RE: Missouri CVS Pharmacy, L.L.C. (the "Applicant") / SE Corner of Providence and  
Broadway / Rezoning and C-P Plan Approval (Case No. 13-127)

## Design Parameters Worksheet

### **General Review Comments**

CVS#10004  
SEC Providence Rd & East Broadway  
Columbia, MO 65203

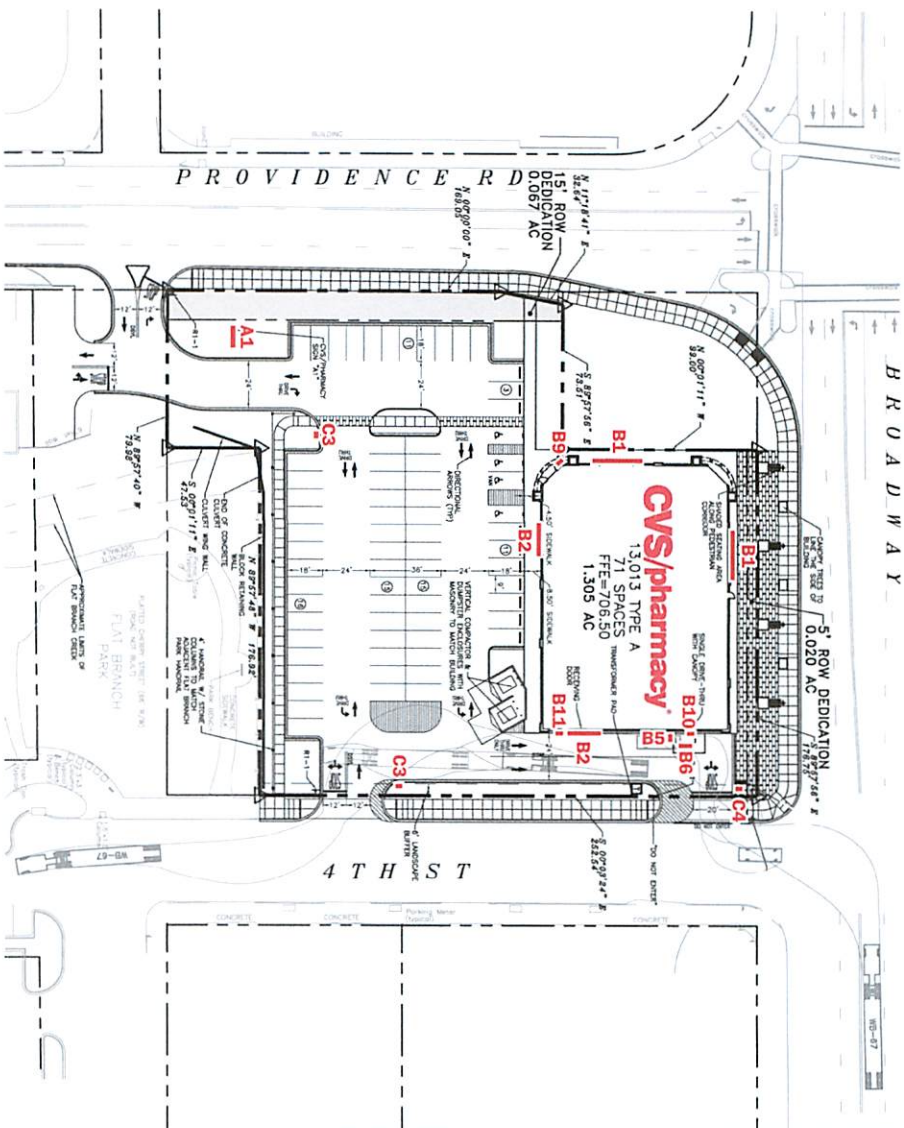
9. Comment: Provide details for CVS Pharmacy sign "AI".

**Response: See revised plan and design parameters.**
